ADDRESS: 700-02 AND 704 CHESTNUT ST

Proposal: Demolish building, construct addition

Review Requested: In Concept

**THE MINUTES OF THE 720TH STATED MEETING OF THE
PHILADELPHIA HISTORICAL COMMISSION**

3 HIST-ELEV-WEST
1" = 20'-0"

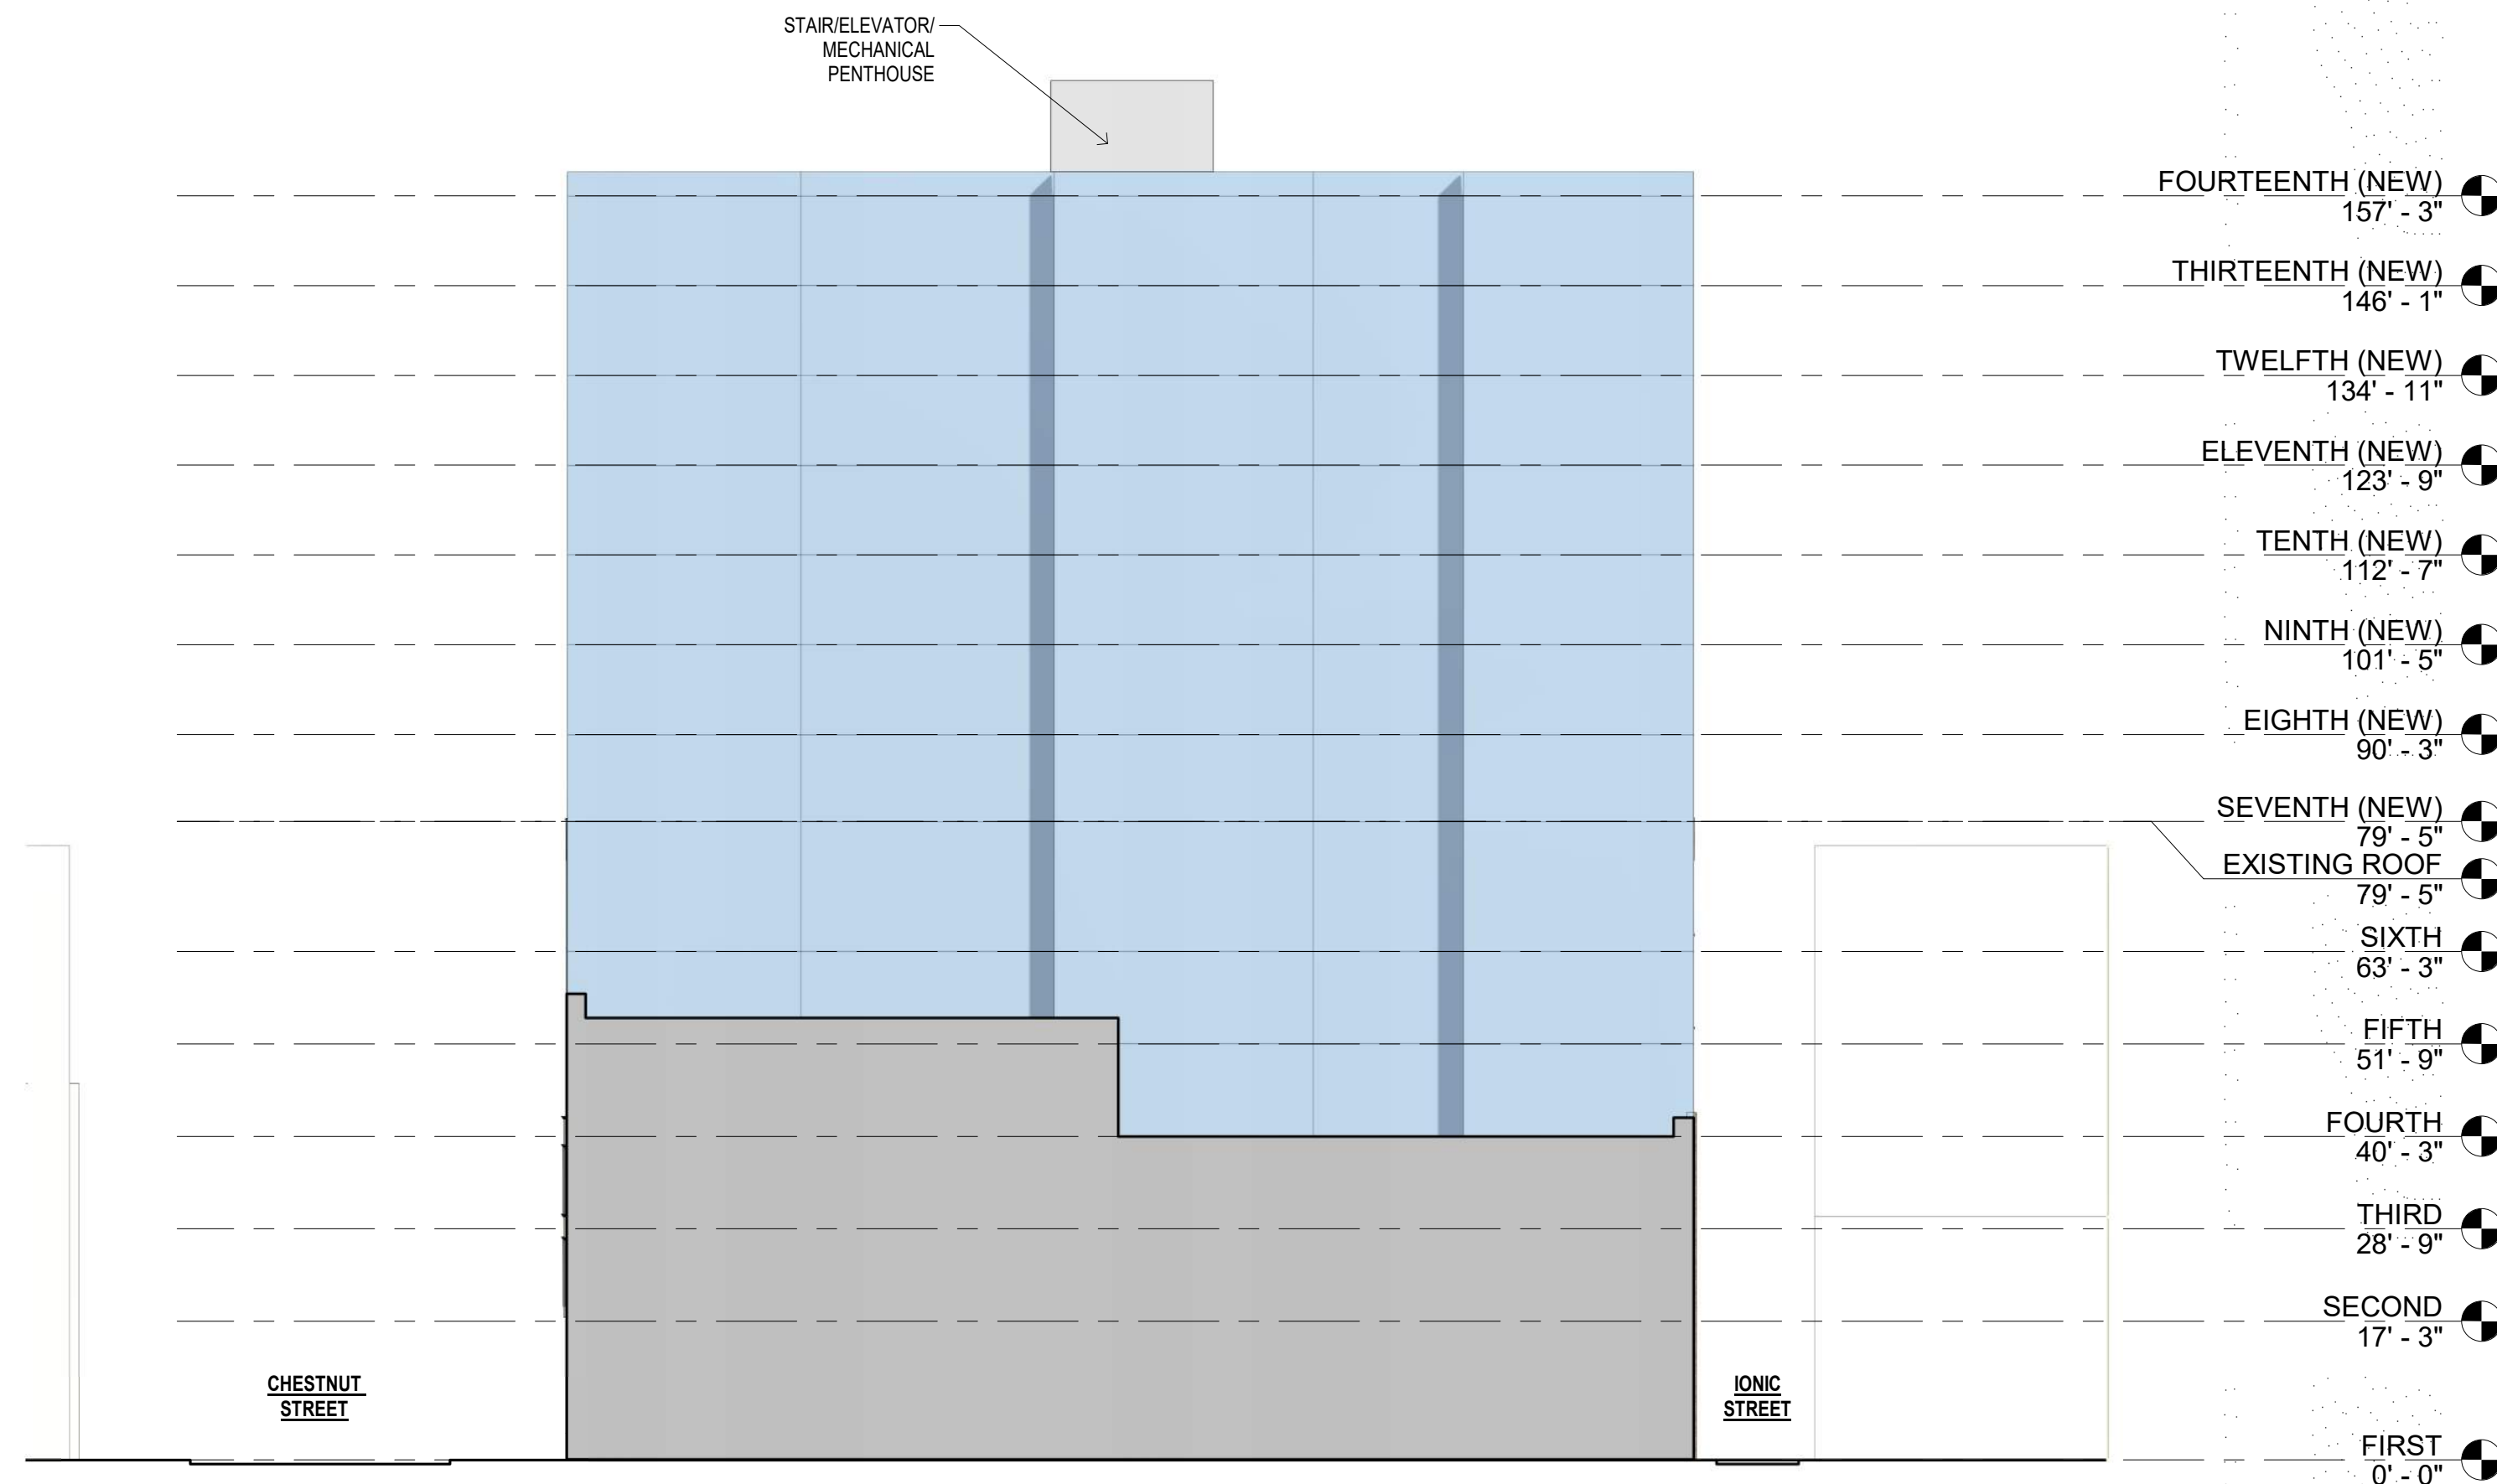
- Mr. McCoubrey asked about the appearance of the west-facing wall.
 - Mr. Schultz displayed an elevation drawing and explained that it would be a party wall with some setbacks and windows. He stated that he could add articulation to the blank sections of the wall.

- Mr. McCoubrey suggested that they include the adjacent buildings in their drawings so that the Historical Commission can understand the scale and context. He stated that a large setback will be needed at Chestnut Street. He added that the proposed height is much too tall.
